Re: 469-483 Balmain Road, Lilyfield

Reference is made to our engagement to provide a statement in response to Item 5 within correspondence prepared by Inner West Council dated 12 October 2023 as below.

3. Access to Lobby of Building Part D, E & F

Figure 2 Highlighted entrance doorways for Building Part D, E, F Lobby

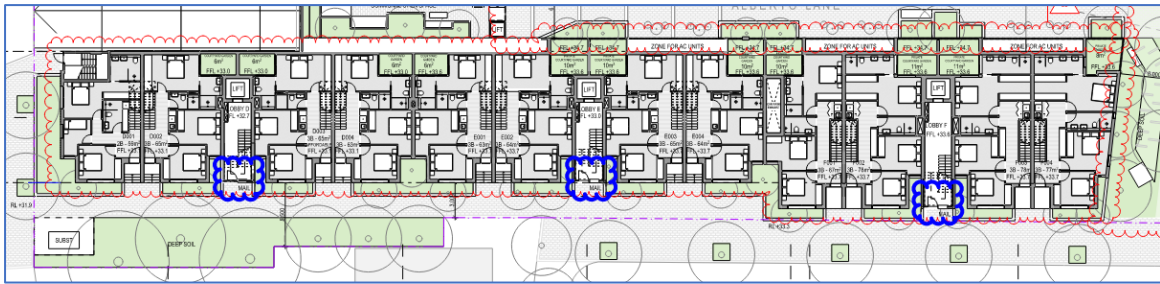
It has been noted that an entrance doorway is proposed to provide access to the lobbies of Building Part D, E & F from Fred Street. The entrance doorway must form part of a Continuous Accessible Paths of travel in compliance with AS 1428.1-2009 and circulation at doorways shall have a gradient and crossfall not steeper than 1 in 40.

Figure 3 RL levels provided by CHROFI

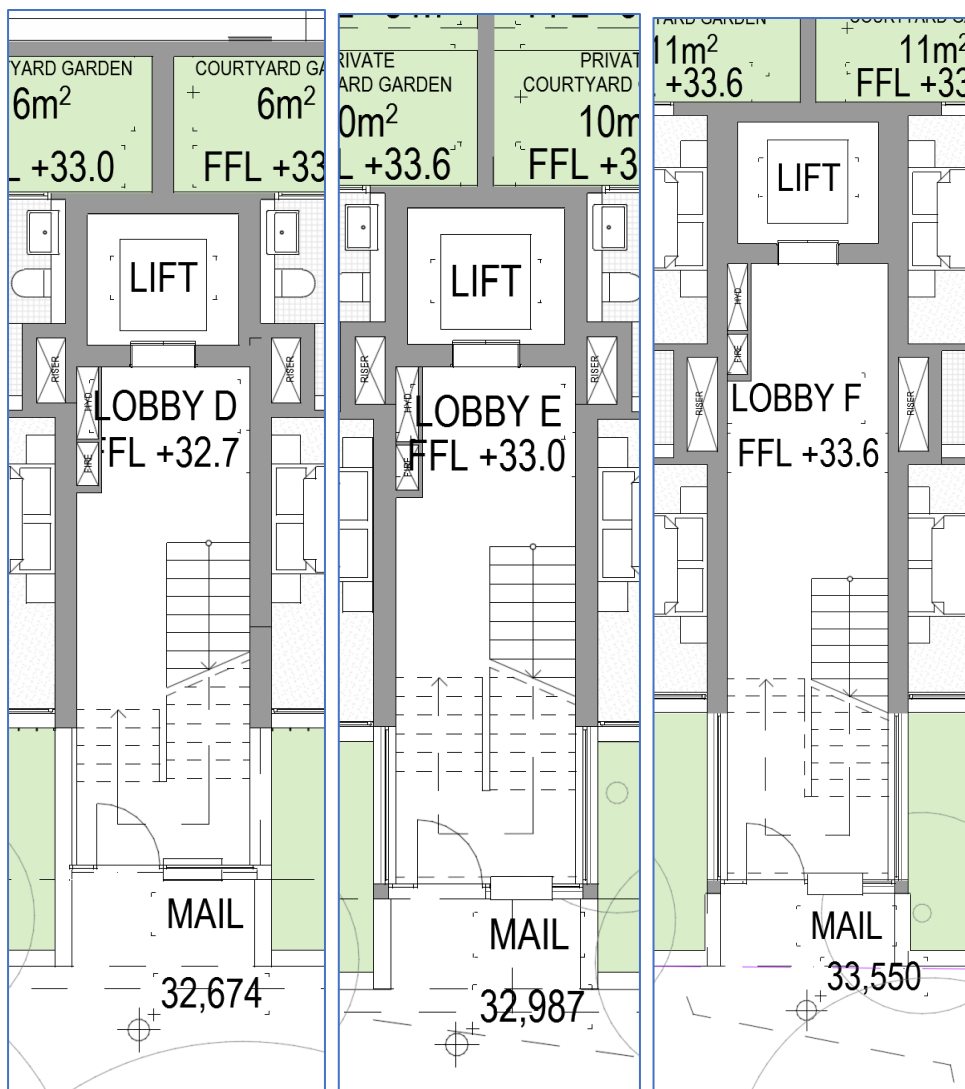
Email correspondence has been provided by CHROFI dated 07 December 2023 in relation to the difference in RL levels at entrance doorways of Lobby D, E & F:

Door threshold is at 26mm ($32.7\text{m} - 32.674\text{m} = 0.026\text{m}$). It is recommended a threshold ramp in compliance with AS 1428.1 2009 to be implemented at the doorway.

Door threshold is at 13mm ($33\text{m} - 32.987\text{m} = 0.013\text{m}$). It is recommended a threshold ramp in compliance with AS 1428.1 2009 to be implemented at the doorway.

Door threshold is at 50mm ($33.6\text{m} - 33.55\text{m} = 0.05\text{m}$). It is recommended a walkway at 1:40 with length of 2m in compliance with AS 1428.1 2009 to be implemented at the doorway.
